Docket Item # 2
BAR CASE # 2013-00096

BAR Meeting
May 1, 2013

ISSUE: Alterations
APPLICANT: Sherry Schiller
LOCATION: 524 S. Pitt Street
ZONE: RM/Residential

The applicant requests approval of a Certificate of Appropriateness for alterations at 524 South Pitt Street, including:

Attachment 1
TRONI
524 S. PITT

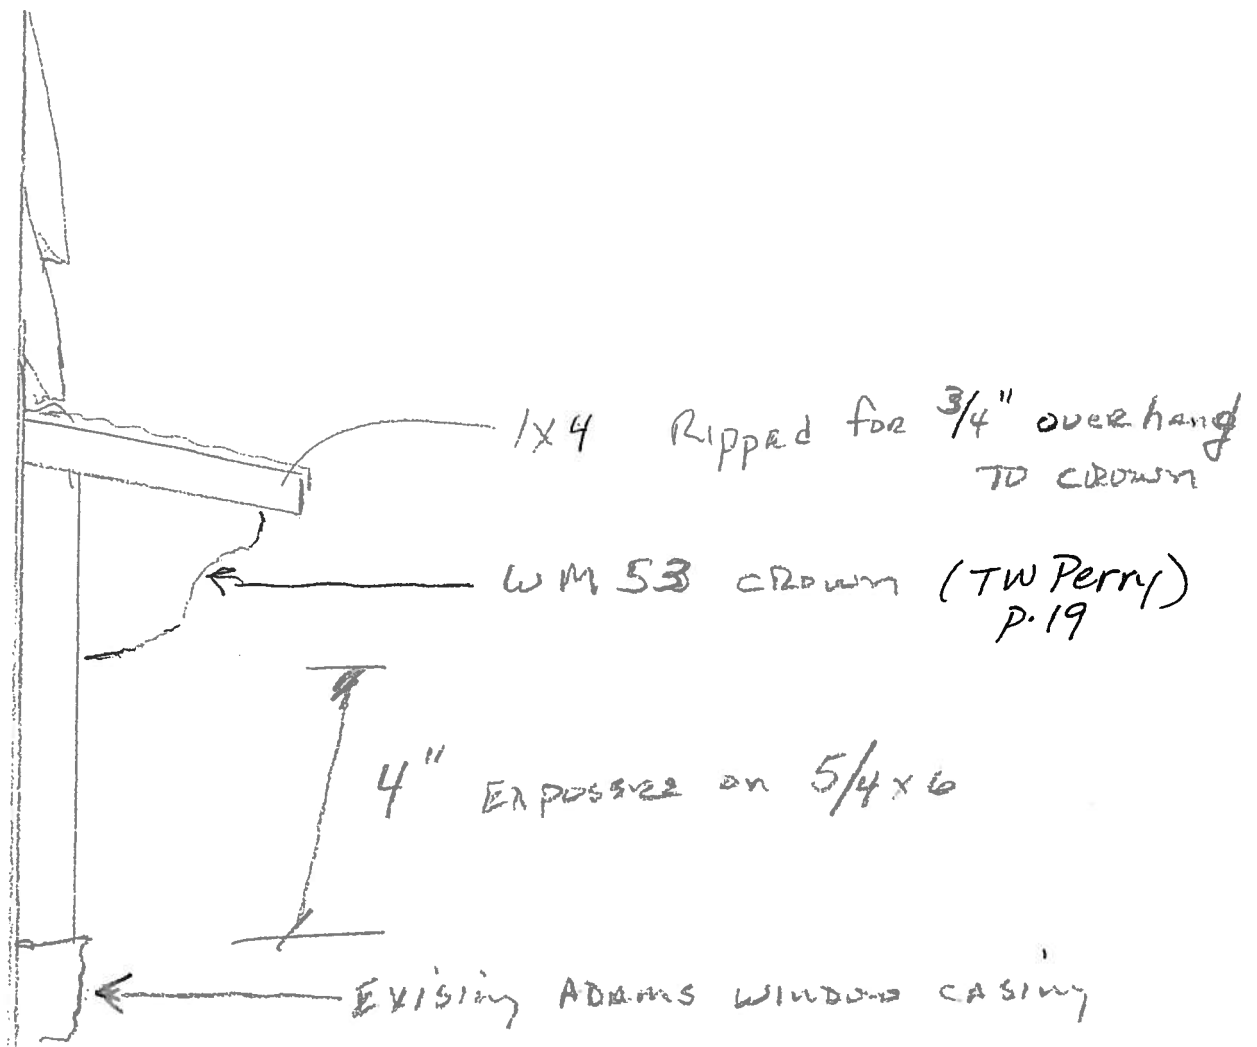
Staff has no objection to the addition of decorative trim consisting of brackets and crown molding above the existing windows on the front facade. The present brick mold trim is likely simpler than what would have been used on a three bay wide, Second Empire style house. Furthermore, because the proportions of the existing windows on this infill house are slightly squat and not as tall as would historically have been used on a Victorian building, the new trim will provide a more vertical proportion and help visually offset the large areas of siding on the front facade. Staff recommends that the crown mold used between the new brackets above the window reflect the profile of the existing molding between the brackets on the cornice, as was typical historically.

4006

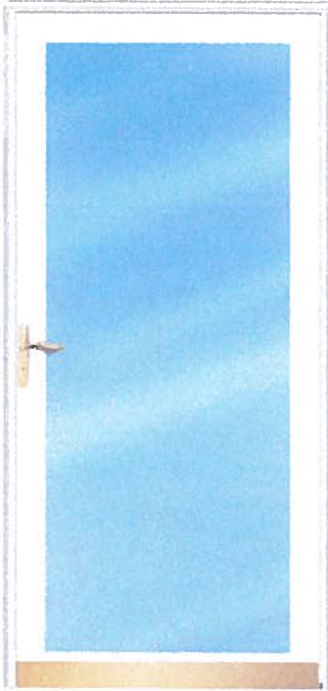
The proposed four-panel door with frosted glazing is also more typical of the Victorian period than the existing 6-panel Federal style entry door. Finally, Staff supports the installation of the proposed full-light storm door, which complies with the Board's Design Guidelines and is something that Staff would otherwise approve administratively.
